PERMIT NO 01845

REF: 945 HARMONY DR.

CONFIRMING OUR PN CONVERSATION 9-28-89
THE FOLLOWING ADDITIONAL INFORMATION &
CORRECTIONS TO YOUR DRAWING(S) WILL BE
REQUIRED BEFORE A PERMIT CAN BE
ISSUED

RESIDENTIAL PLAN CORRECTION SHEET

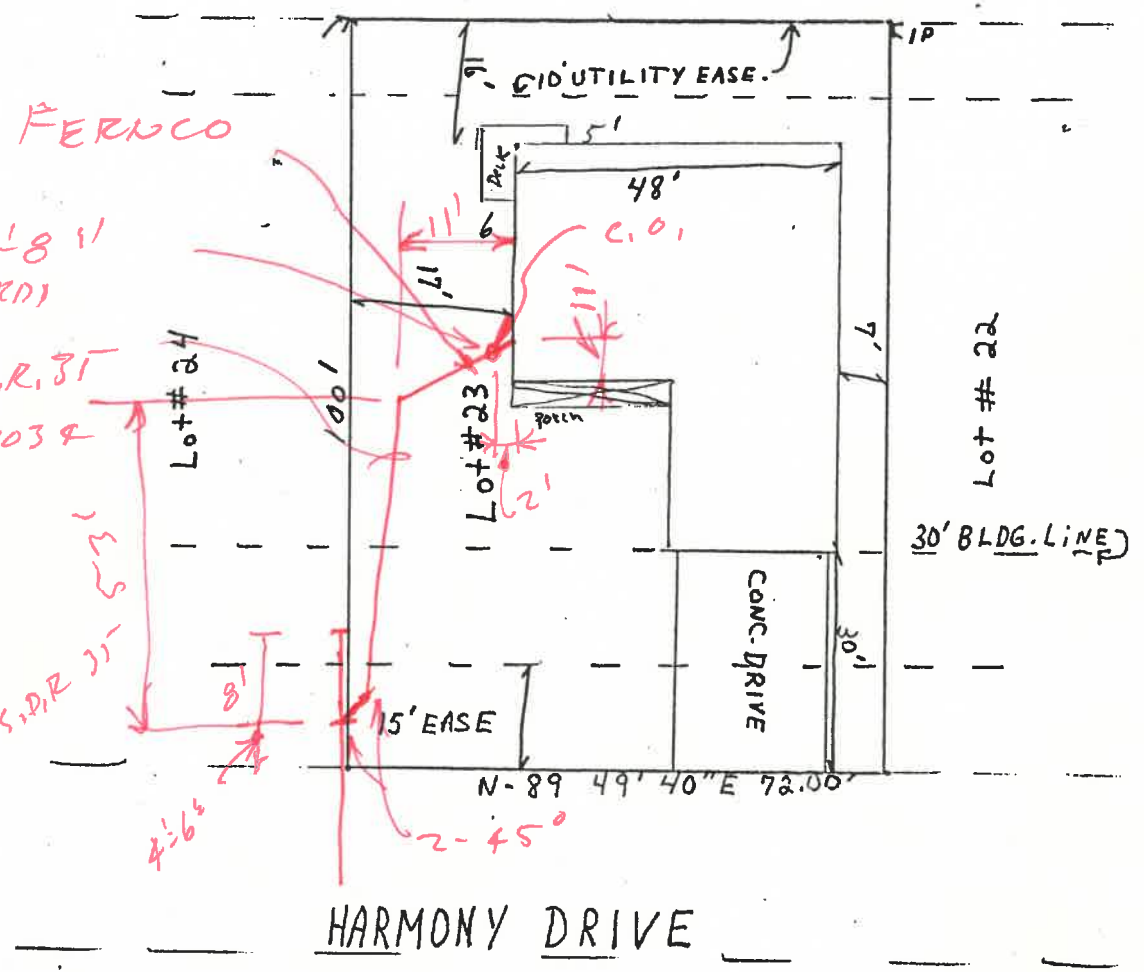
GREG NOTE

THE SEWER TAP IS IN FRONT OF THE HOUSE

STORM LINE ALSO RUNS ACROSS THE FRONT OF THE LOT.
